40787 - 35 Flask Walk - Markup of  
beams to support chimney breast

E&P;  
13/12/2016

Option 2

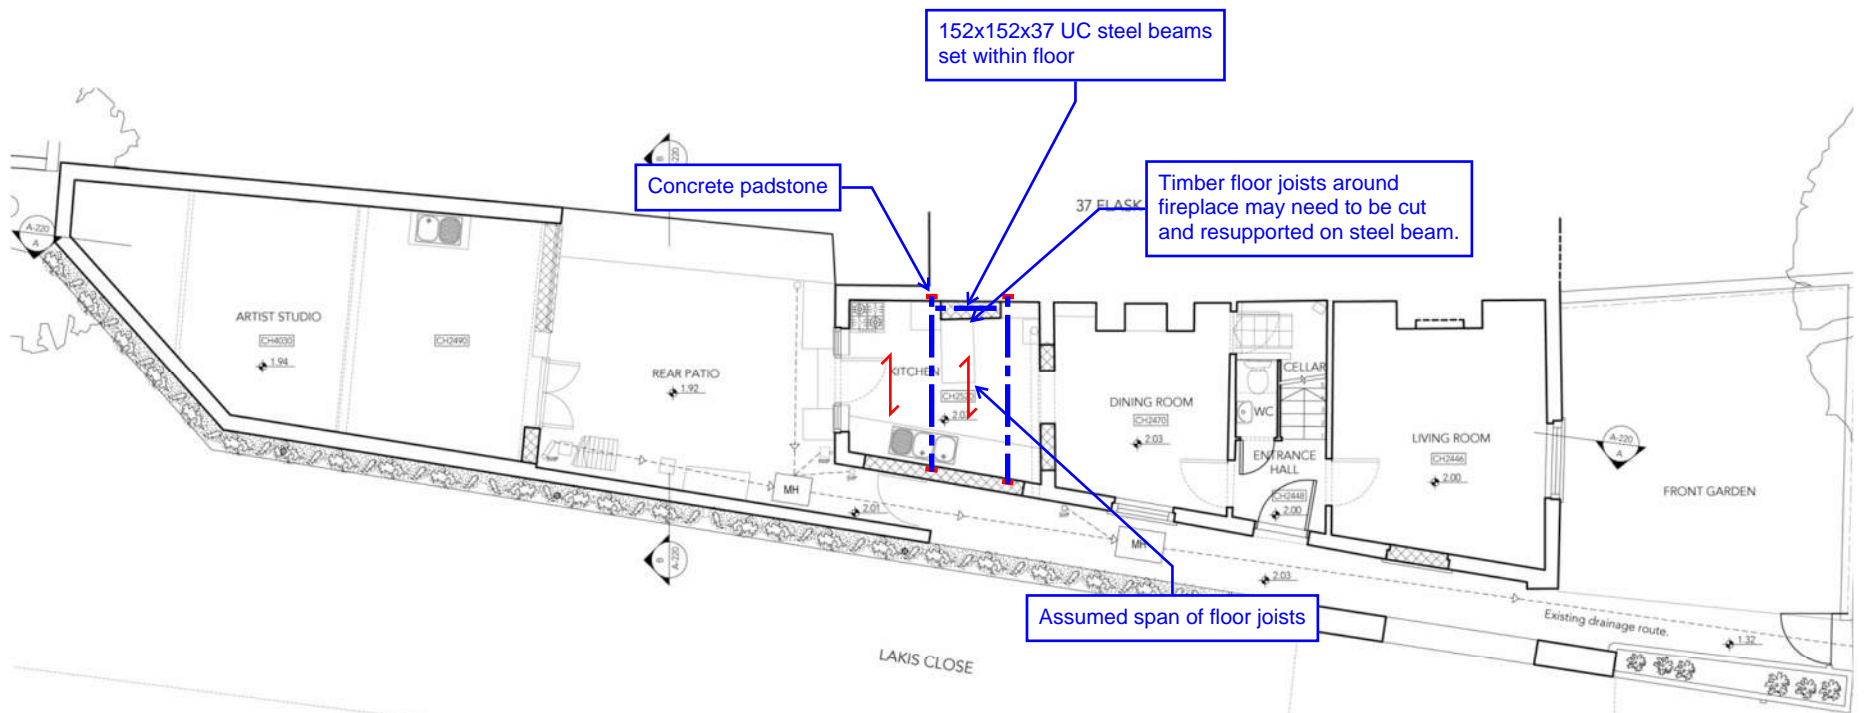
40787 - 35 Flask Walk - Markup of  
beams to support chimney breast
